Report: PUNCHLIST
Function: Test, Adjust, & Balance
Date: 10/01/2025
Completed By: National TAB

PROJECT
09-22-25 QT #0579 OMAHA, NE

Project: 09-22-25 QT #0579 OMAHA, NE

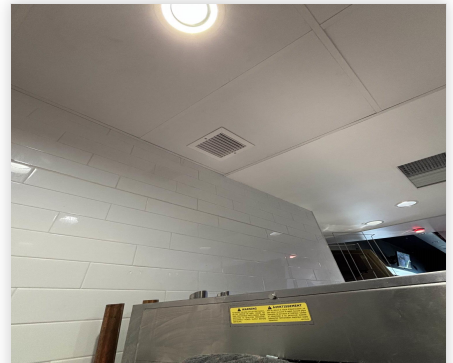
Issue Name : EF2: Missing Damper
Description : The damper for the grille above the combi-oven is missing. Unable to balance airflow to design amount.
Created By : National TAB **Assigned To :** National TAB - Dan Hertenstein
Status : Open
Priority : Urgent **Asset Tag :** EF2
Originated Date : 09/26/2025 - Kalen Kemp - National TAB
